Subject: Summary of Key Feedback Provided by SENEAM Experts

I would like to take this opportunity to thank you for supporting the 5 June 2014 visit to MITRE by CTA. Rodrigo Bruce Magallón and CTA. José Arturo Enríquez. The visit included a full-day of detailed presentations and discussions regarding MITRE's previous Nuevo Aeropuerto Internacional de la Ciudad de México (NAICM) airspace work, as well as its recent Hidalgo-and Santa Lucía Military Base (Santa Lucía)-related aeronautical studies. Their visit was of critical importance in order to obtain important aeronautical-and Air Traffic Control (ATC)-related feedback.

**Figure C-1. Preliminary VFR Helicopter Airspace Sectors and Altitudes
(with terrain penetrations)**

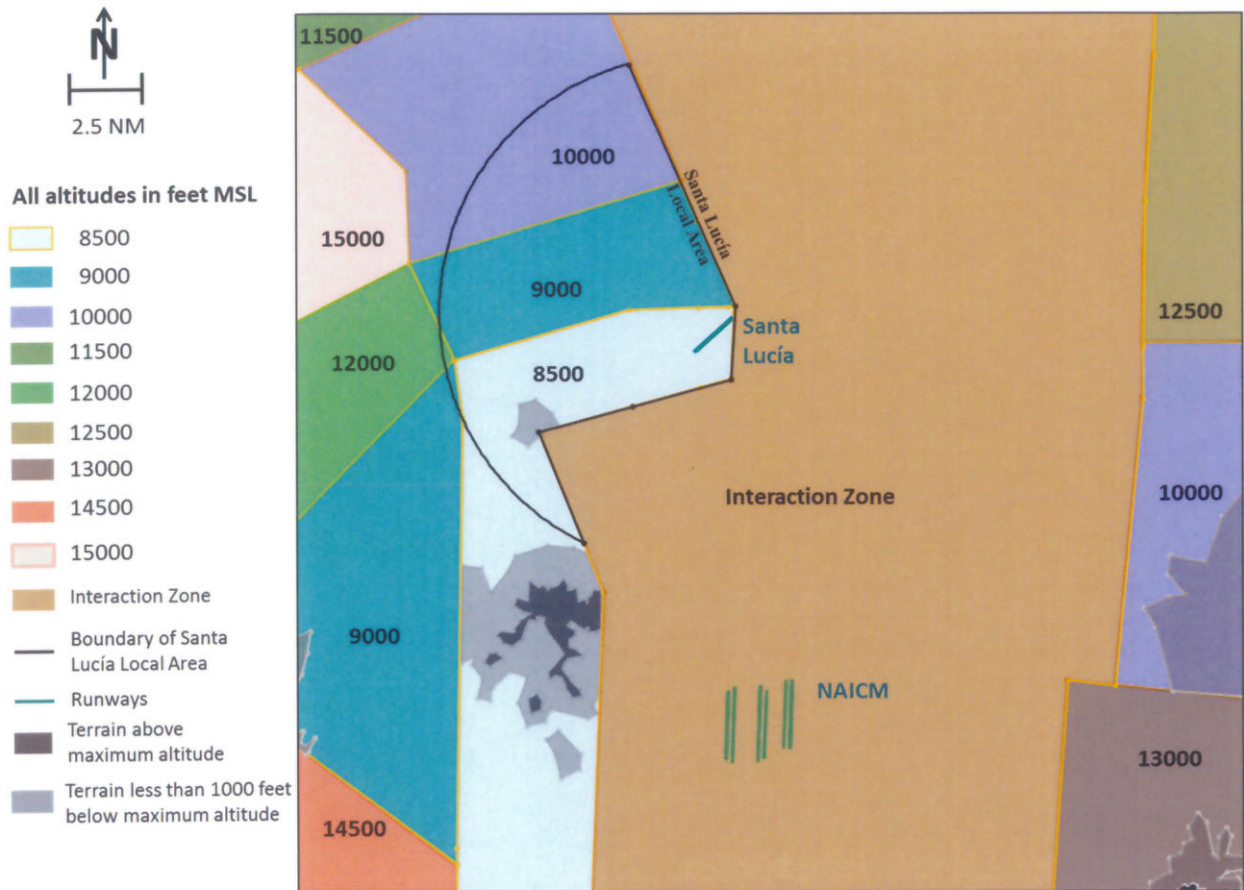
Appendix C to this letter shows the lateral dimensions of various sectors of airspace around NAICM and Santa Lucía, and the maximum permissible altitude within the sectors where VFR helicopters could potentially be allowed to operate safely. CTAs Magallón and Enríquez were in overall agreement with MITRE's findings. Other areas where helicopter arrival and departure operations could *potentially* be conducted may be considered and analyzed (e.g., farther north and east of Santa Lucía).

Figure D-1. Preliminary East VFR Helicopter Route

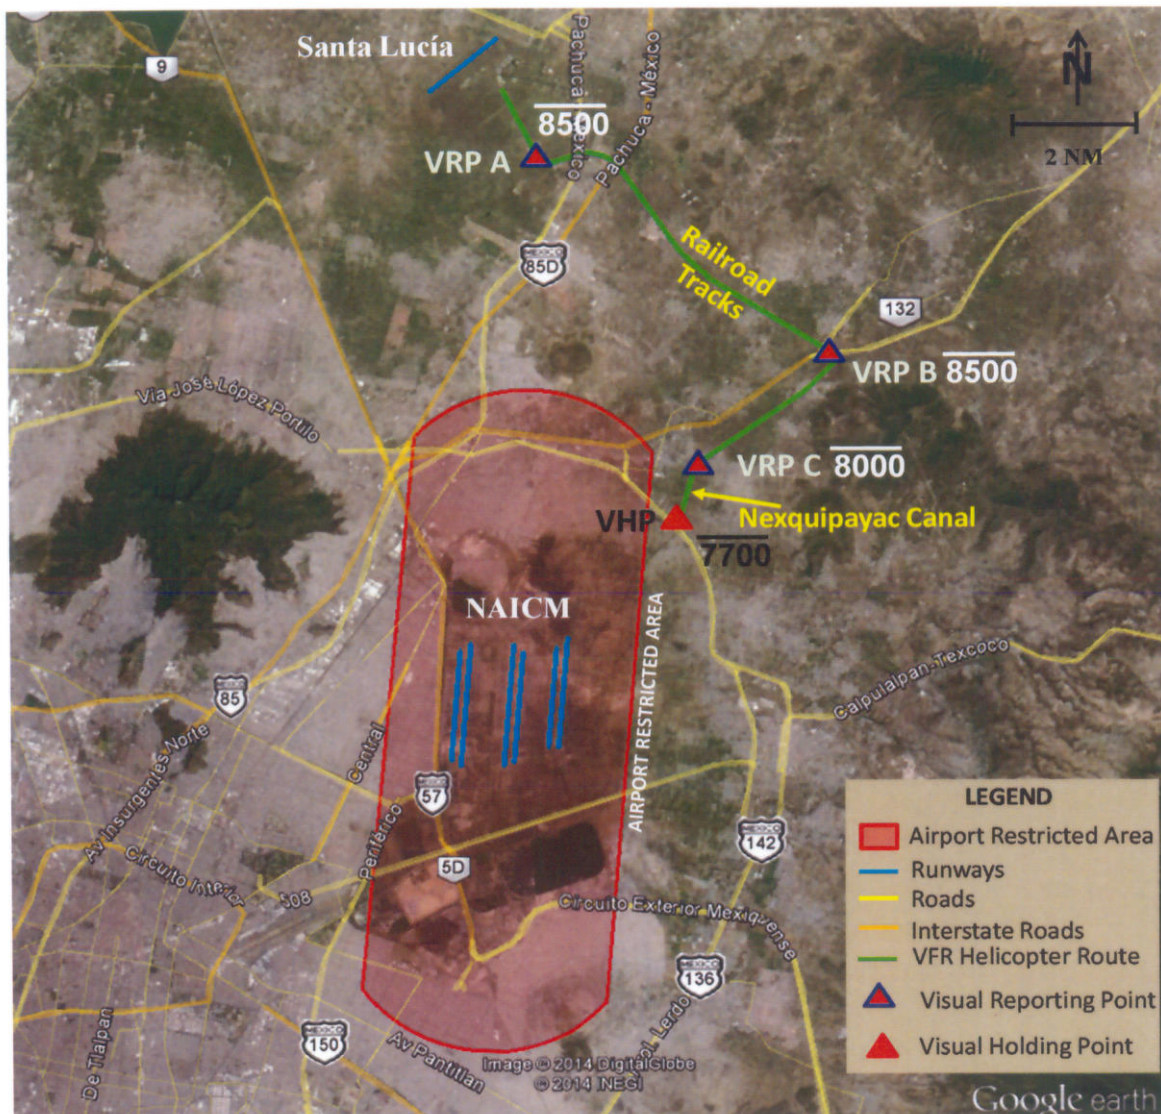
Per Appendix D to this letter, two potential helicopter routes were developed: an East and a West VFR Helicopter Route. CTAs Magallón and Enríquez were also in overall agreement with MITRE's work on this subject.
